HUNTS GROVE
GLOUCESTERSHIRE

Section 73 Planning Application

ADDENDUM TO THE DESIGN & ACCESS STATEMENT

June 2015

LAND USE PLAN

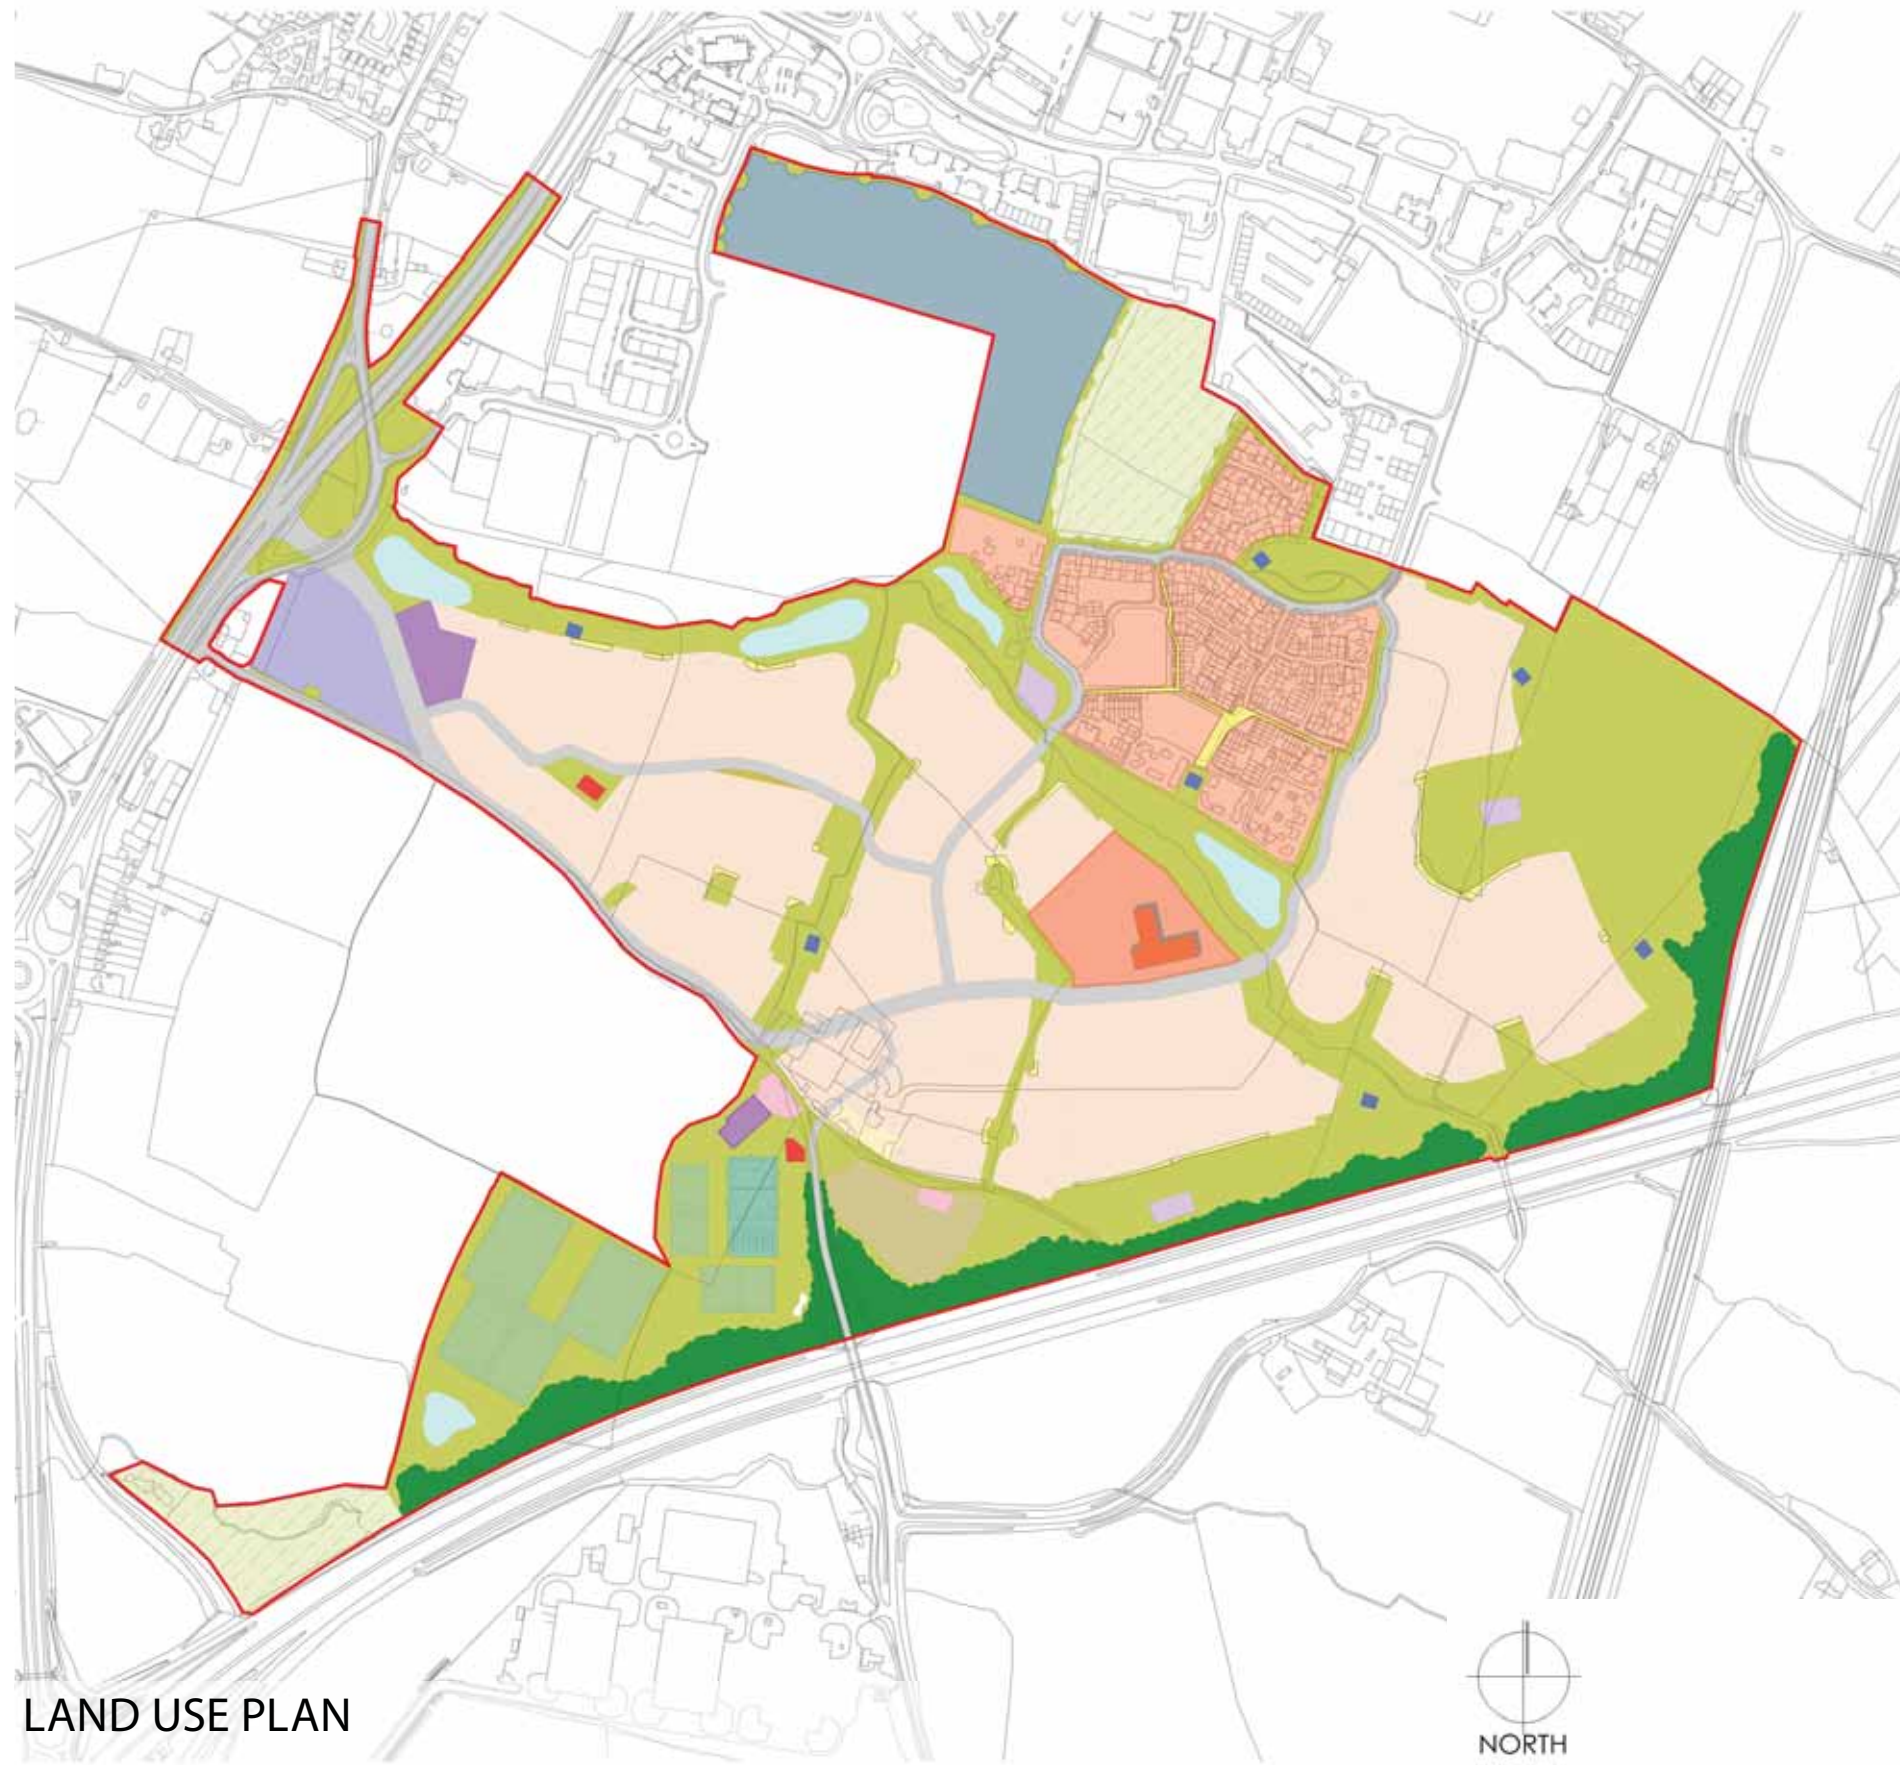
Key Changes

- A reduction in infrastructure including squares and highways with a corresponding increase in residential land;
- A reduction in the size (and location) of the neighbourhood centre to better reflect the demand and viability for such uses; and
- A slight reduction (0.1ha) of the primary school provision to reflect discussions following the planning application.

RESIDENTIAL DENSITY

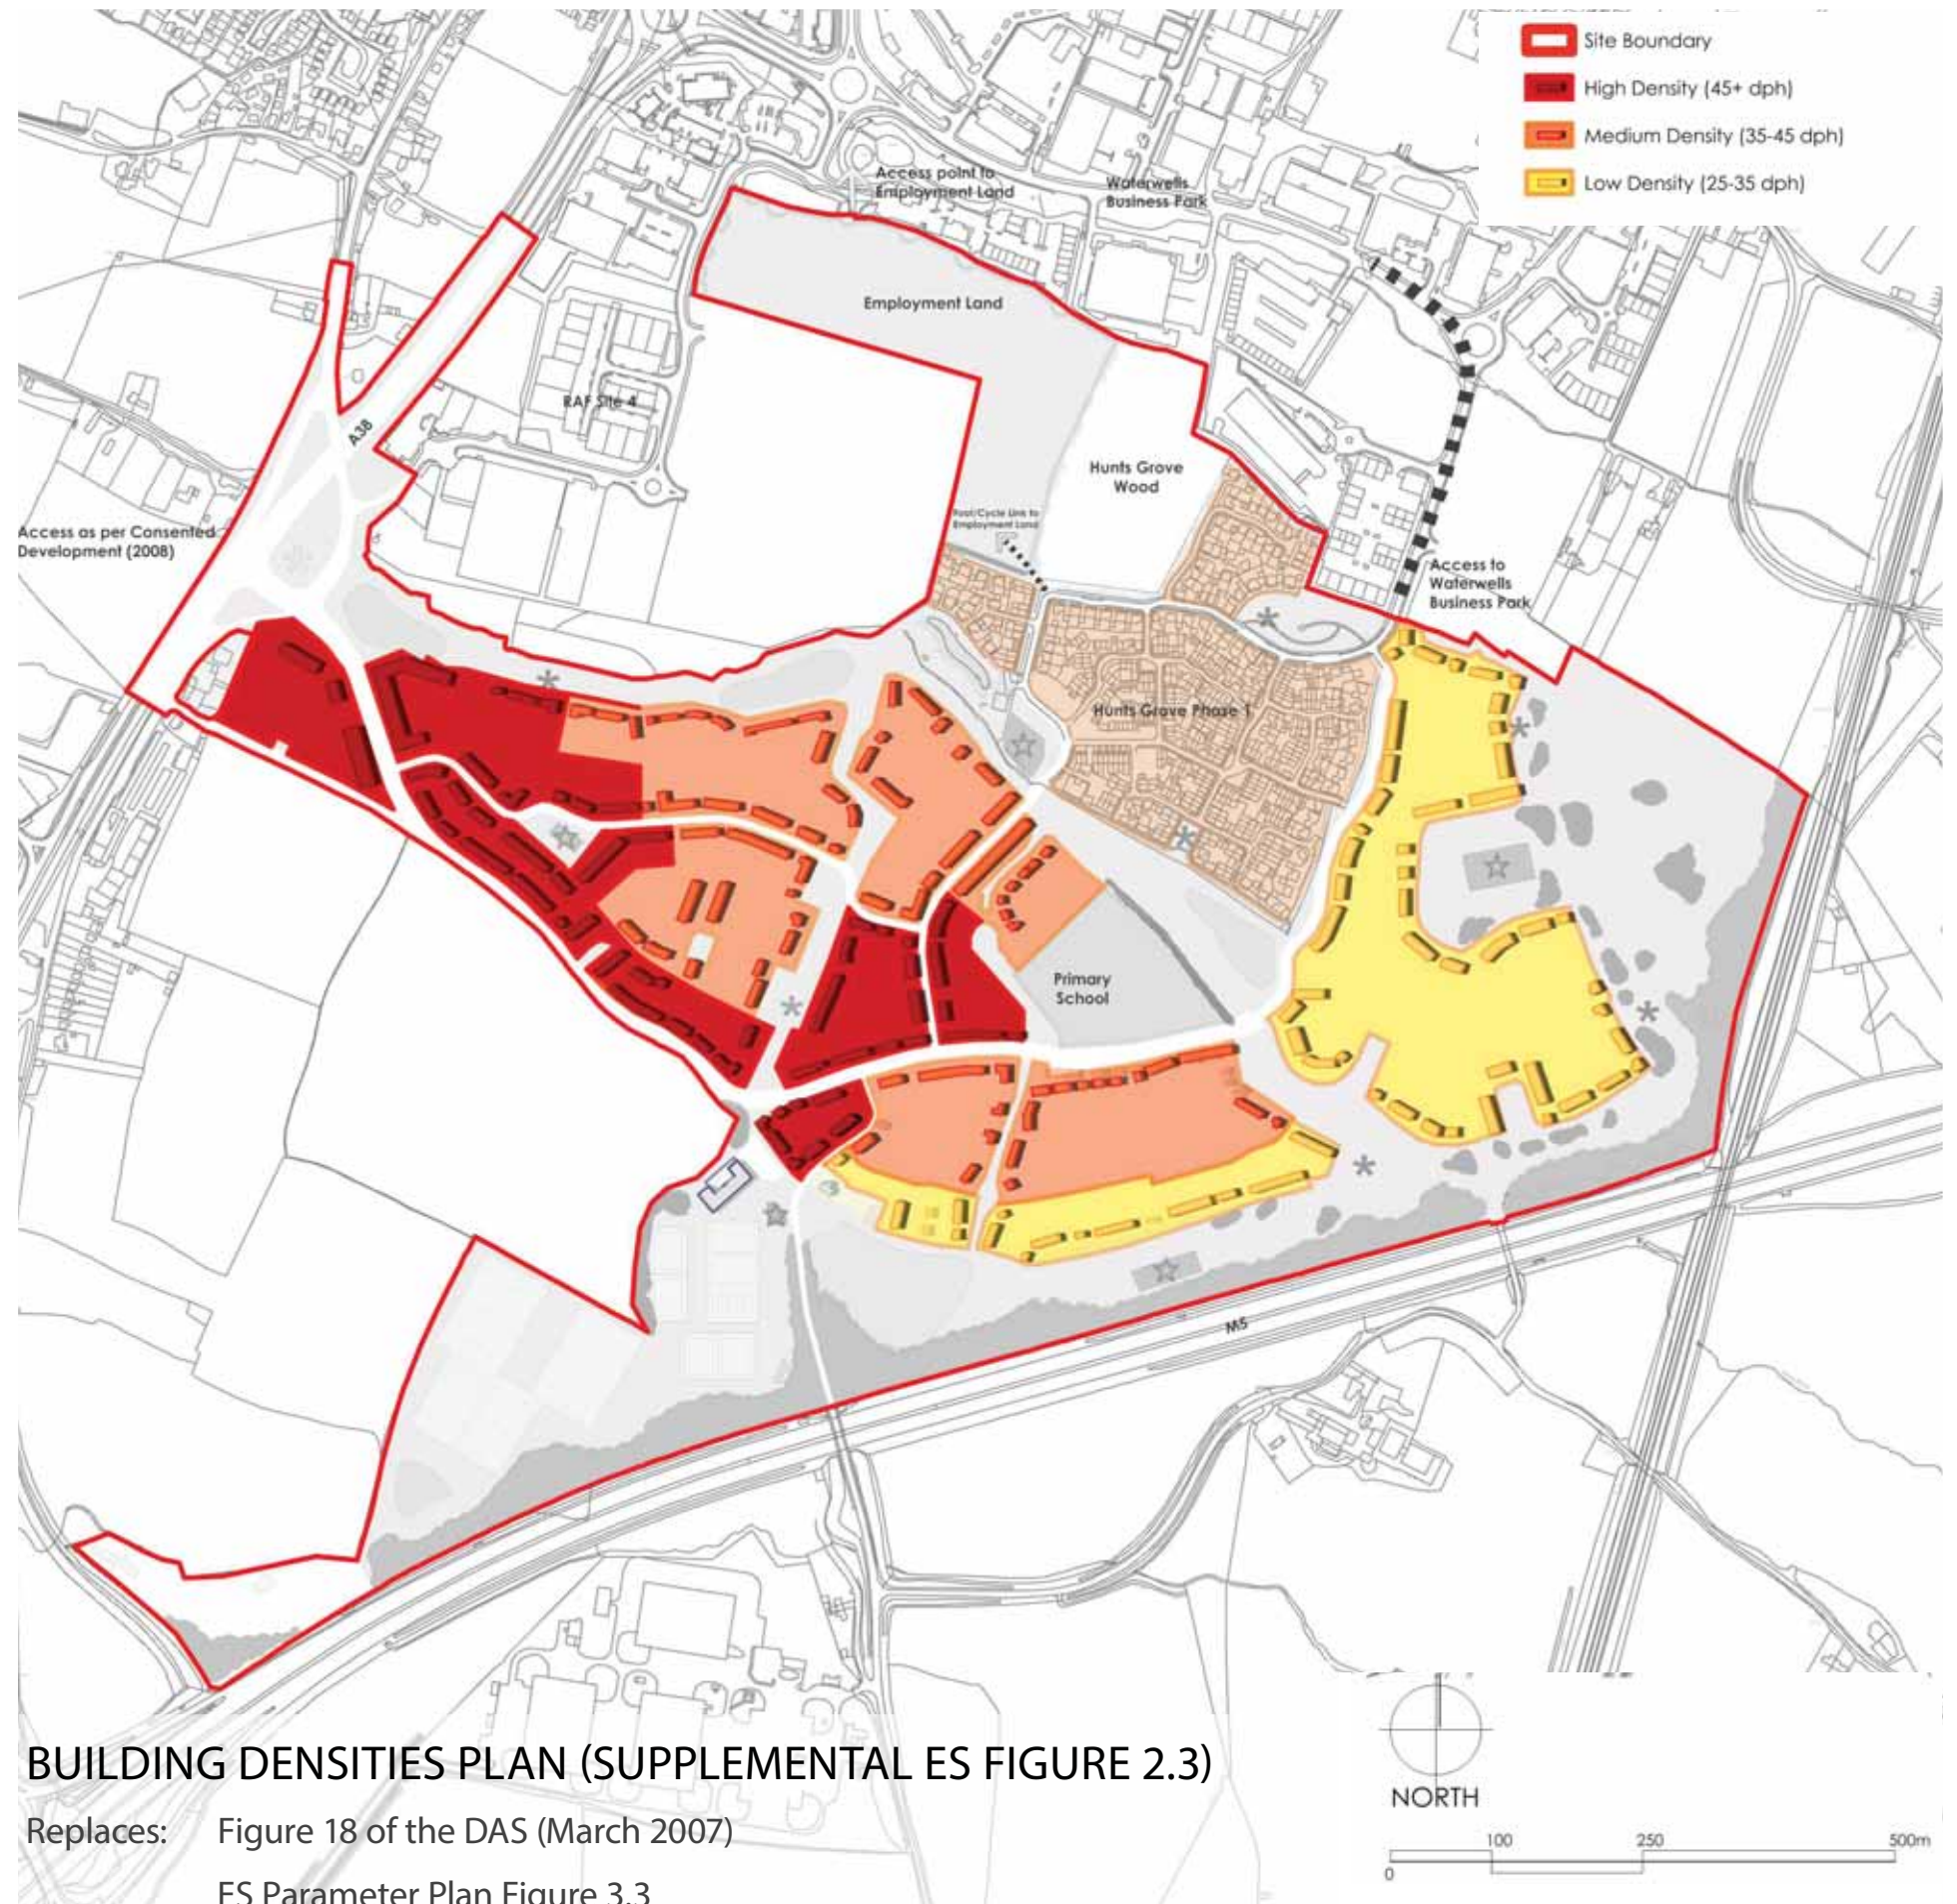
Key Change

- *With the proposed relocation of the neighbourhood centre and desire to create a landmark gateway to the development it is logical to also provide the higher density area at the west of the site.*

BUILDING HEIGHTS PLAN (SUPPLEMENTAL ES FIGURE 2.2)

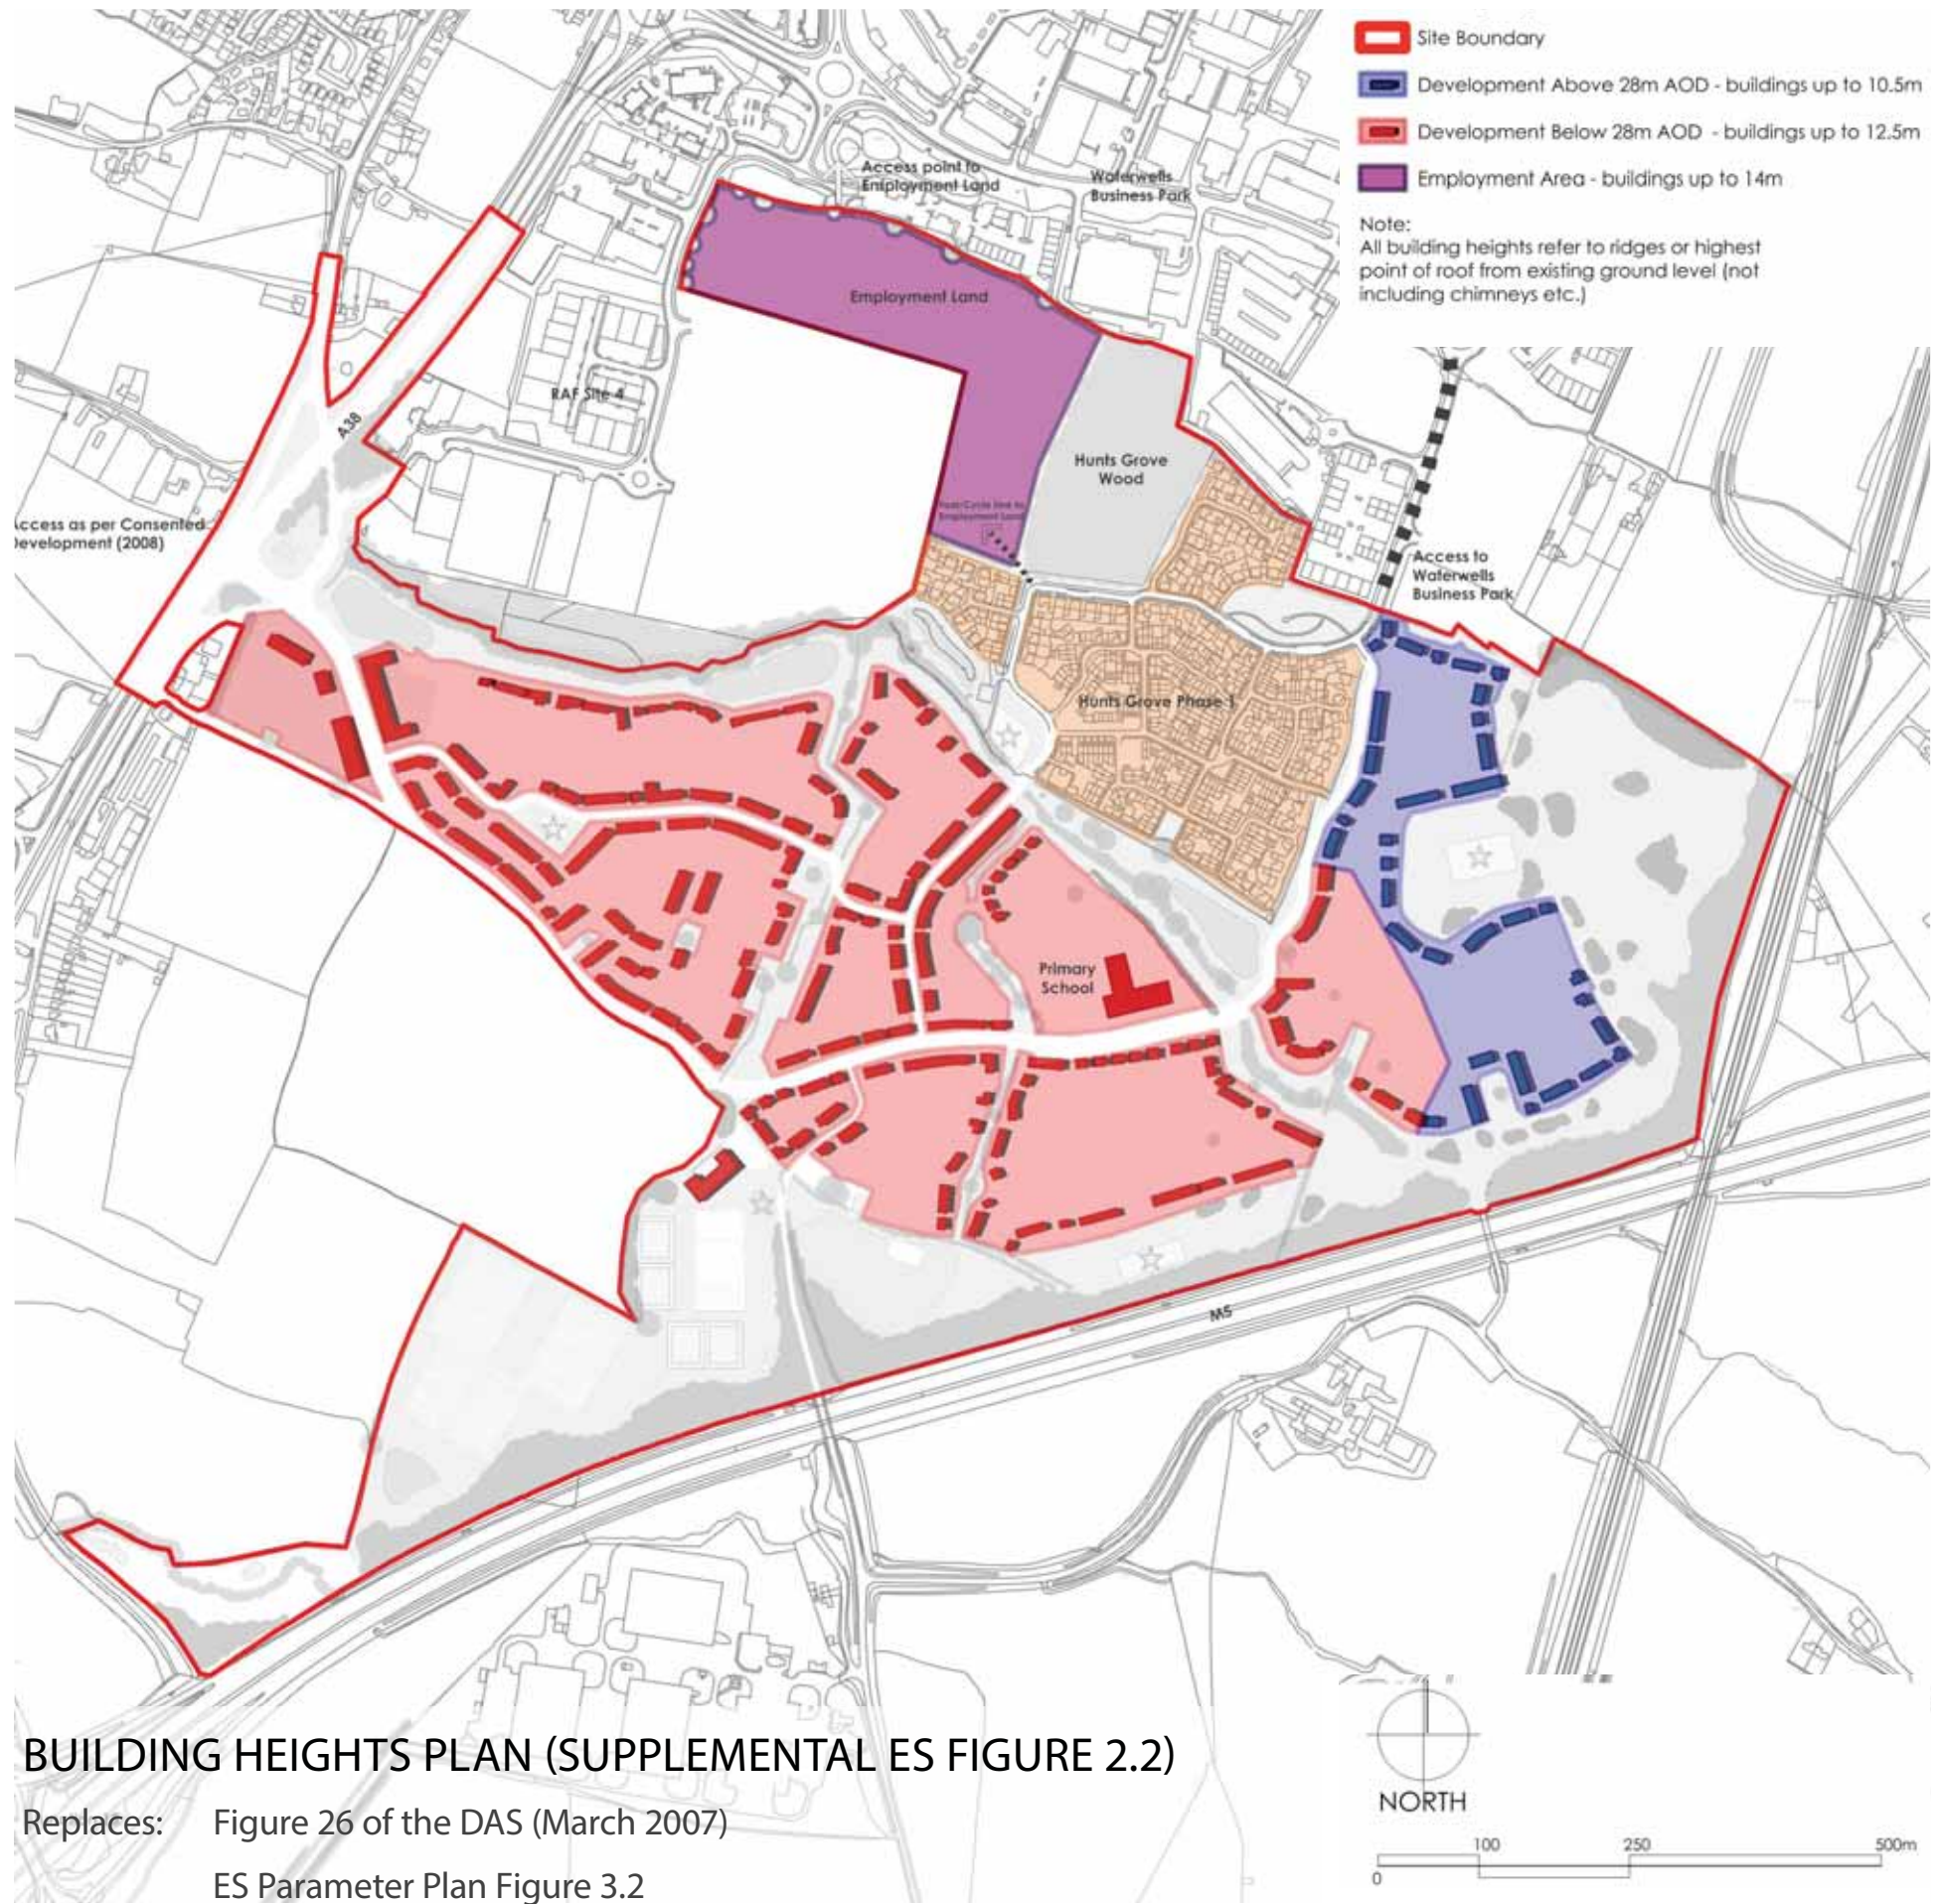
Key Change

- *Removal of the upper band of building heights in the central part of the site (and former location of the neighbourhood centre)*
